ADMINISTRATIVE AMENDMENT (PD) ADD2022-00190

ADMINISTRATIVE AMENDMENT
LEE COUNTY, FLORIDA

WHEREAS, Lee County Homes Associates I, LLP filed an application for an administrative amendment to a Residential Planned Development on a project known as Buckingham 345 to:

BUCKINGHAM 345

6 30' LANDSCAPE BUFFER SCALE: 1" = 10'

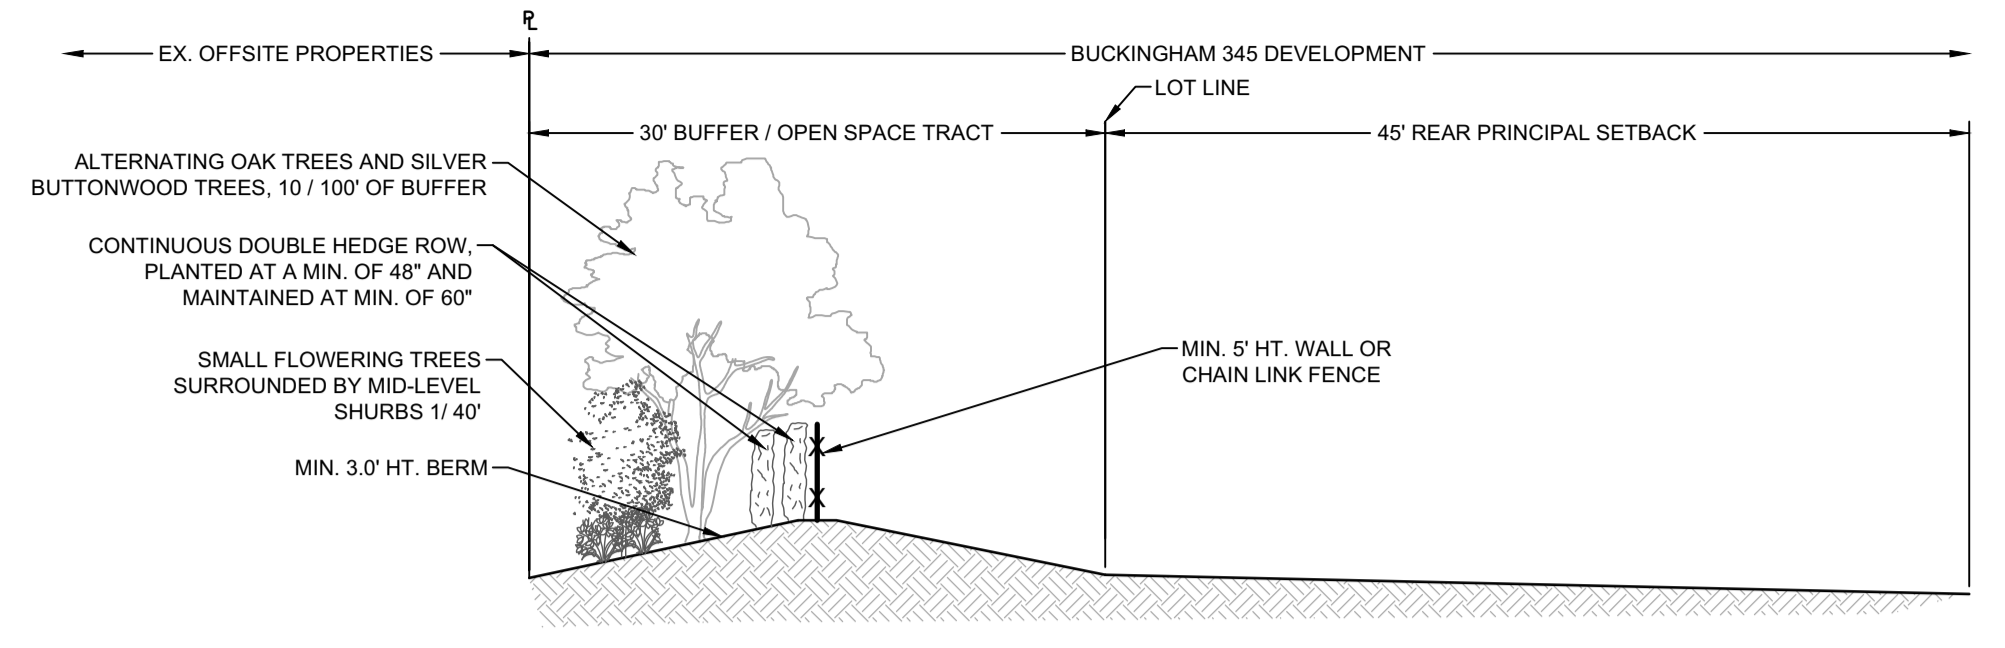
WHEREAS, the applicant is proposing to amend Conditions 6.a (Southern Property Line Buffer) and 6.c (Buffers adjacent to Portico and Internal Right-of-Way) of Resolution Z-21-002; and

WHEREAS, the proposed revised Condition 6.a will allow a wall or a chain link fence with a berm/fence combination and larger shrubs to provide visual screening; and

Development order plans must depict a 30-foot-wide buffer along the southern property line (excluding indigenous preserve area) with the development order establishing lots adjacent to this property boundary. The 30-foot-wide buffer must abide by the following:

- i. *Contain a berm, a minimum of 3 feet in height, with a wall or chain link fence at least five feet in height, except where it encroaches in the upland preserve as shown on the MCP;*

- ii. ***Vegetation installed between the southern property line and the minimum eight-foot berm/wall or chain link fence combination must contain ten trees (alternating oak and Silver Buttonwood trees) per 100 linear feet and a double hedge row;***
 - iii. ***Trees must be 10 feet, two-inch caliper, and four-foot spread;***
 - iv. ***Shrubs comprising the double hedgerow must be at least 48 inches in height at time of planting to create a visual screen and must be maintained at 60 inches in height; and***
 - v. ***Existing indigenous native vegetation may be counted toward the vegetation requirements of this condition.***
- c. **Buffer Adjacent to Portico and Internal Right-of-Way**

MASTER CONCEPT PLAN

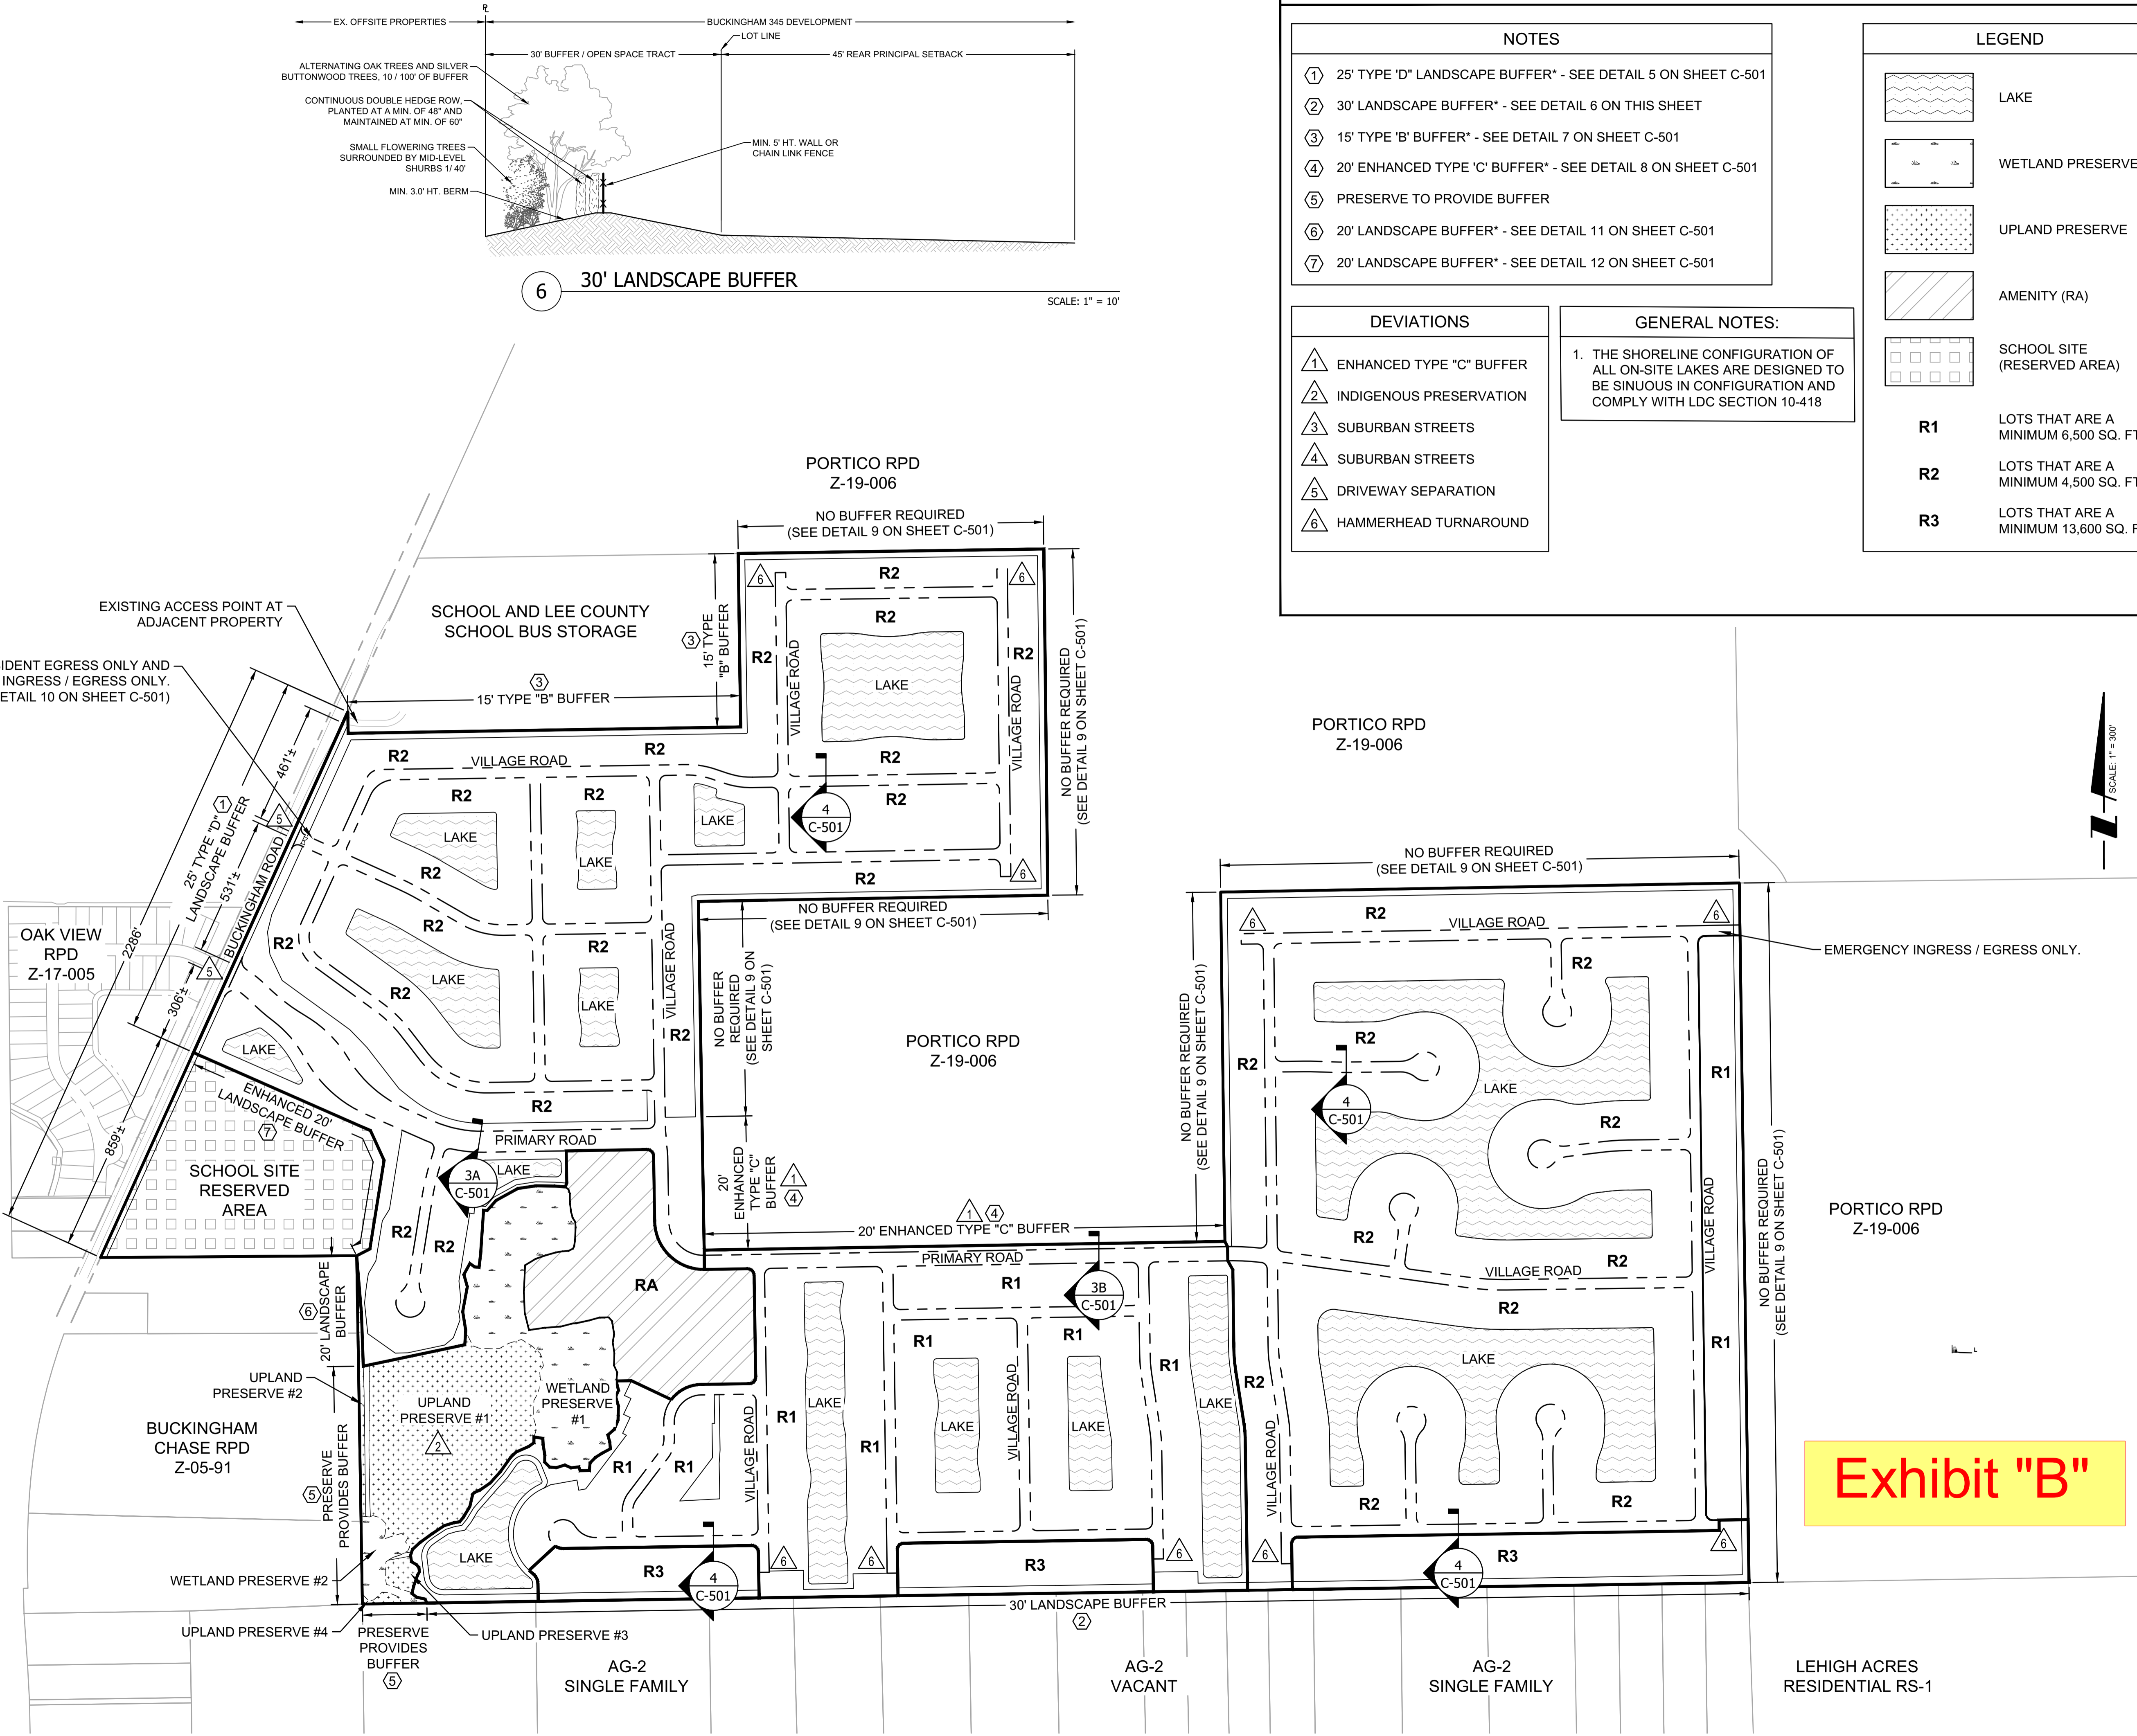
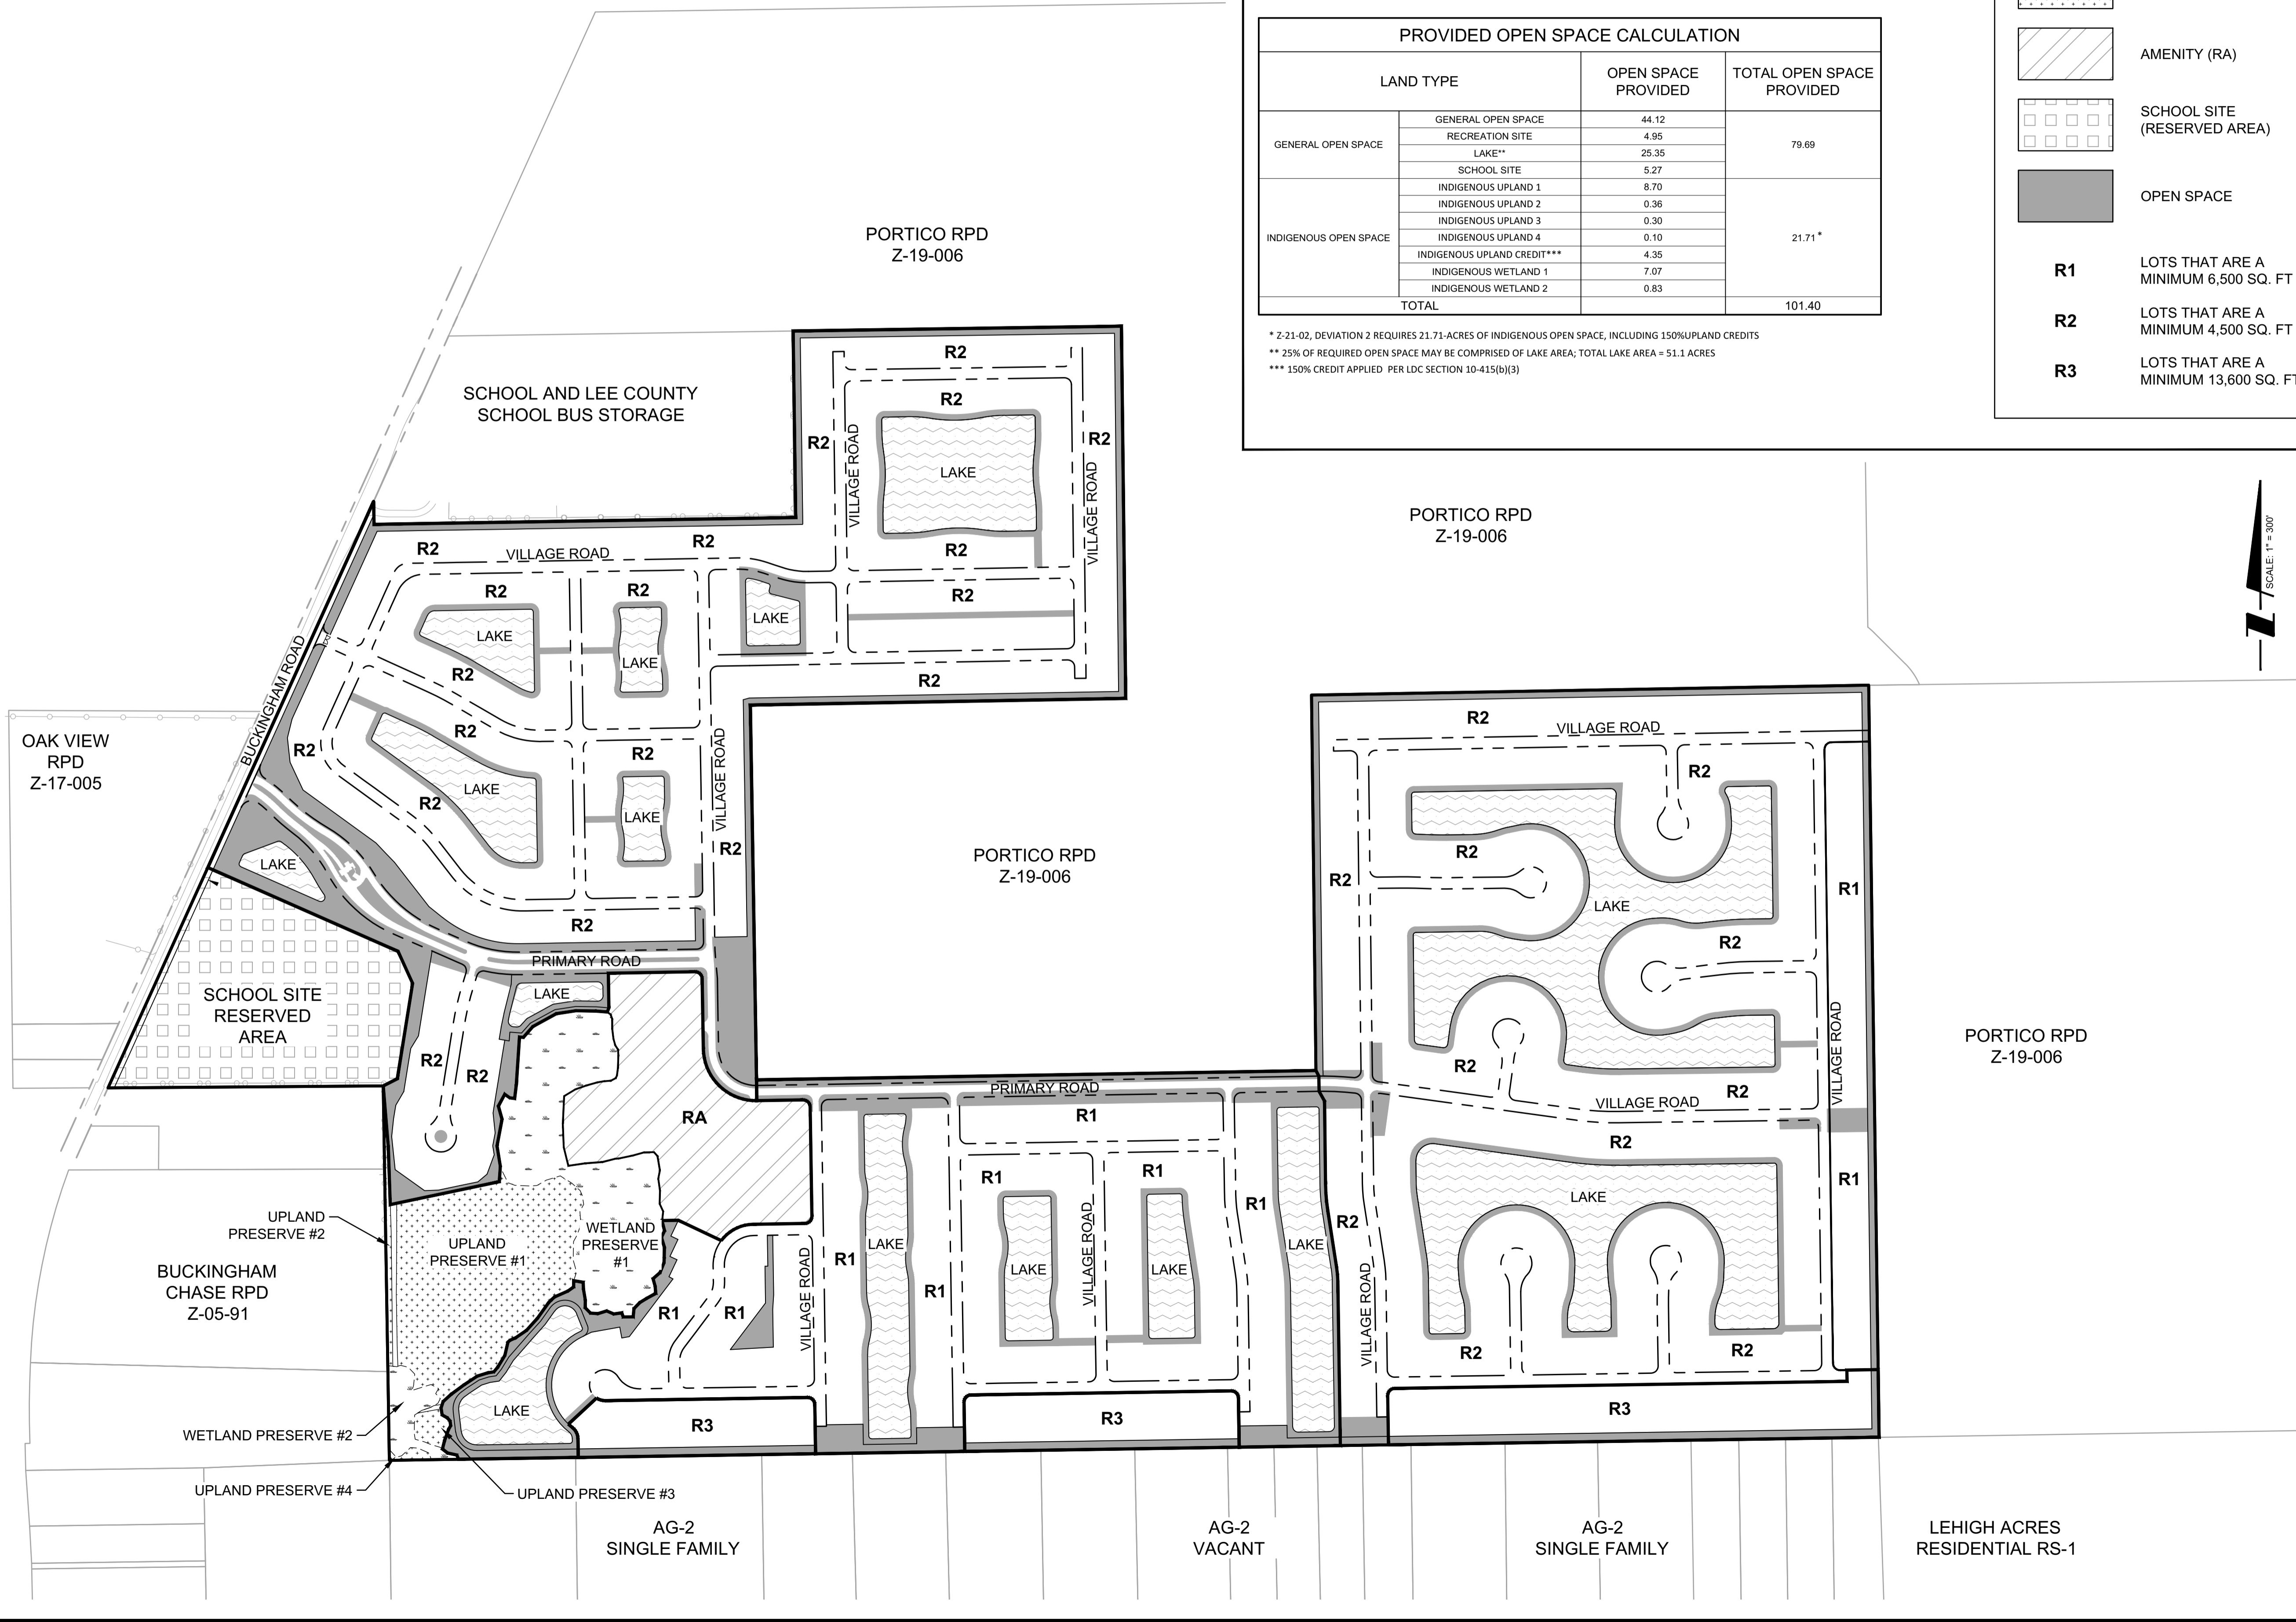
WHEREAS, the applicant proposes to amend the Master Concept plan to:

- 1- Increase R-1 Development Area from 68.34 acres to 74.83 acres;
- 2- Decrease R-2 Development Area from 241.95 acres to 211.55 acres;
- 3- Increase R-3 Development Area from 14.39 acres to 16.45 acres;
- 4- Increase RA Development Area from 6.92 acres to 10.87 acres; and
- 5- Amend the Land Use Summary to include Upland/Wetland Preserve; and

WHEREAS, the applicant also requests to amend Deviation #5 concerning "Access Connection Separation" to allow the main entrance to Buckingham 345 to align with the entrance to Oak View RPD along Buckingham Road; and

WHEREAS, due to the proposed changes to the Master Concept Plan Deviation #7 is no longer necessary and the applicant proposed to withdraw this Deviation; and

1. The Development must be in compliance with the amended Master Concept Plan, revised on 05/04/2023. Master Concept Plan for ADD2022-00190 is hereby APPROVED and adopted. A reduced copy is attached hereto as Exhibit "B".
2. The terms and conditions of the original zoning resolution remain in full force and effect, except as amended herein.
3. The condition of approval of Deviation #2 of Resolution Z-21-002 is hereby amended as follows:
